2004-2008 RX-8

ENGINE INTERMEDIATE HOUSING FUEL INJECTOR BORE

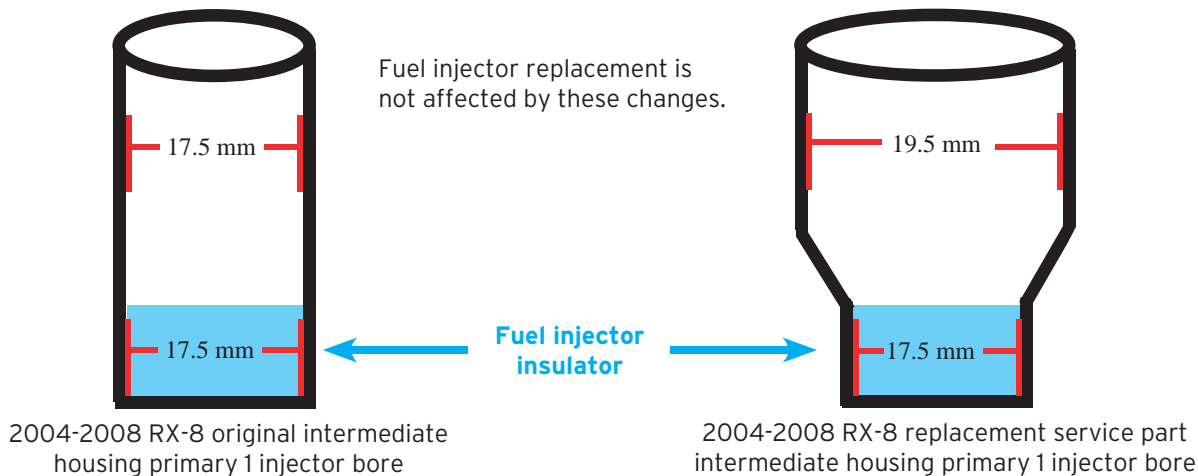
Be advised that the engine intermediate housing primary 1 fuel injector bore diameter may vary:

- The original bore diameter is 17.5 mm
- A replacement intermediate housing service part top bore diameter is 19.5 mm (original bore was 17.5 mm).
- A replacement remanufactured engine may have either a 17.5 mm or a 19.5 mm top bore diameter.
